***CDD Concept Plan #2014-0002, Special Use Permit #2015-0077, Vacation #2015-0002***

***Multiple Addresses: Jefferson Davis Hwy, Fannon St, Oakville St, Swann Ave, Calvert Ave: Oakville Triangle***

Purpose of Application
Approval of CDD Concept Plan for a mixed-use development of the Oakville Triangle.

**Staff Recommendation: APPROVAL WITH CONDITIONS**

**Exhibit 1.** Preliminary Phasing Plan (from A4.00 dated 9/15/15)

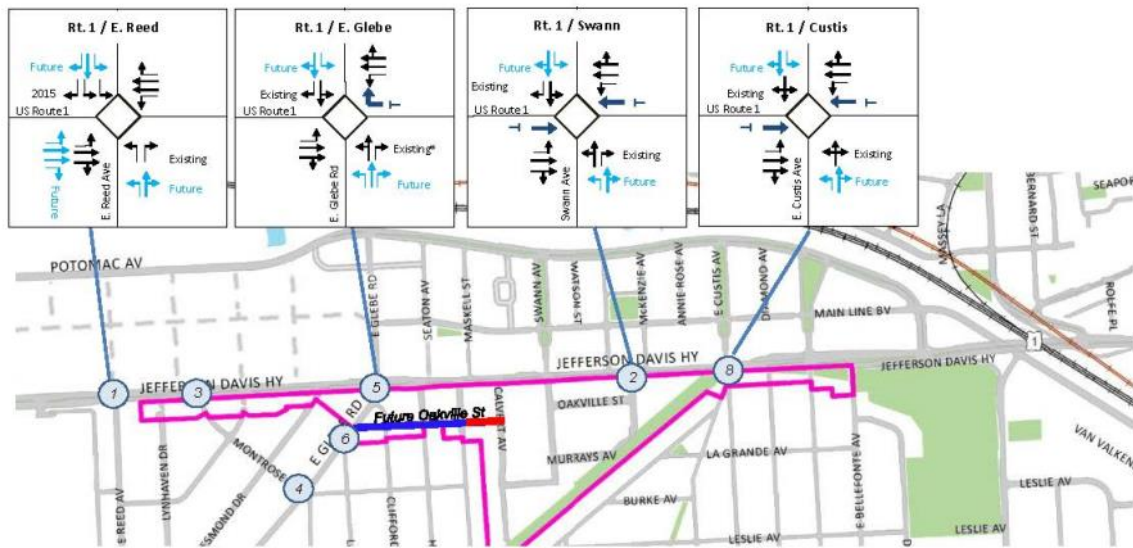
- a. The subject site of the CDP application, hereafter referred to as the “CDP area” is subject to the conditions herein.
  - b. The applicant’s preliminary submission defined construction within two broad timeframes, Phases 1 and 2 (referred to as “Phase 1” and “Phase 2” herein). The extents of the respective development and any associated conditions phases shall be as shown in the Preliminary submission sheet A4.00 ‘Phasing Plan’ (exhibit 1). (P&Z)

- 24. The applicant shall construct the development in the following phases:
  - a. Block A2 shall not precede construction of any of three Blocks comprising of A1, B, C or D without the approval of the Planning Commission and City Council.
  - b. The Swann Avenue shared-use plaza, to the extents as shown on the applicant's Phasing Plan A4.00 dated 09/15/15 (exhibit 1) between blocks C and D shall be

- constructed and operational prior to the issuance of the first Certificate of Occupancy for either adjacent block.
  - c. The pedestrian plaza, to the extents as shown on the applicant's Phasing Plan A4.00 dated 09/15/15 (exhibit 1), between the buildings on blocks A1 and A2 shall be constructed and operational prior to the issuance of the first Certificate of Occupancy for either adjacent building.
  - d. The at-grade open spaces on blocks C and D adjacent to Park Road shall be constructed and fully operational concurrent with the issuance of the first certificate of occupancy for each block respectively.  
(P&Z)(T&ES)
25. The development of contiguous (exclusive of public street right-of-ways) building(s) shall be done in a manner that facilitates the development and improvements for each side of the public street(s) and adjacent open spaces and/or park(s). (P&Z) (T&ES) (RP&CA)

**Exhibit 4: Interim Plan**

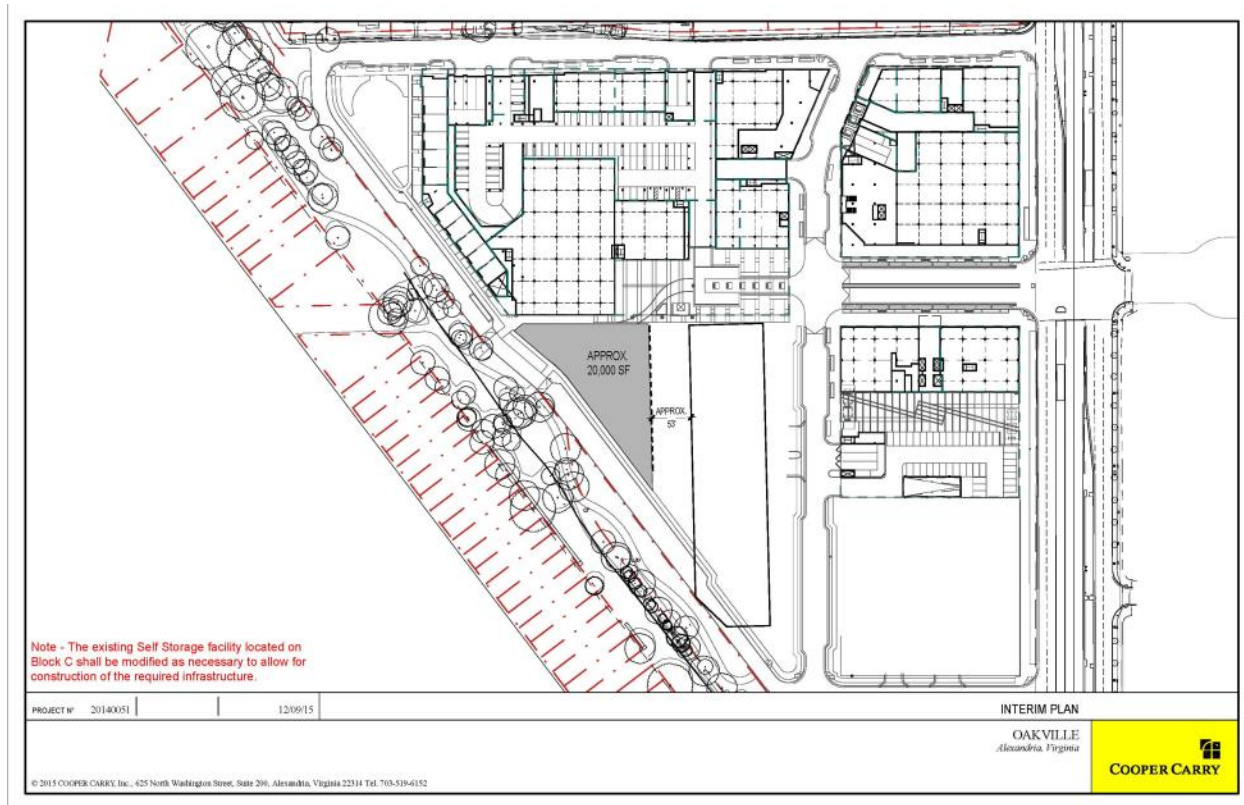
Until Block C develops, a portion of an existing building that serves as a public storage facility will remain and continue to operate as a storage facility (see **exhibit 4**). The applicant has agreed to the remaining portion of the block to serve as an interim open space area. The applicant has also agreed to treat the end of the building facing the plaza with either a mural or some other treatment that will provide an attractive appearance.

49. Retention of the existing storage building as shown in exhibit 4 may be permitted with the following provisions, and to the satisfaction of the Director of Planning and Zoning:

46. The Applicant shall to provide approximately 20,000 sq. ft. of usable area and associated improvements for the use of an interim open space adjacent to the Swann plaza (and generally consistent with exhibit 4) as part of the next and all subsequent submissions of the CDD Concept Design Plan. The interim open space area shall be fully constructed and operational within 6 months the first Certificate of Occupancy permit issued for Block D (P&Z) (RP&CA).
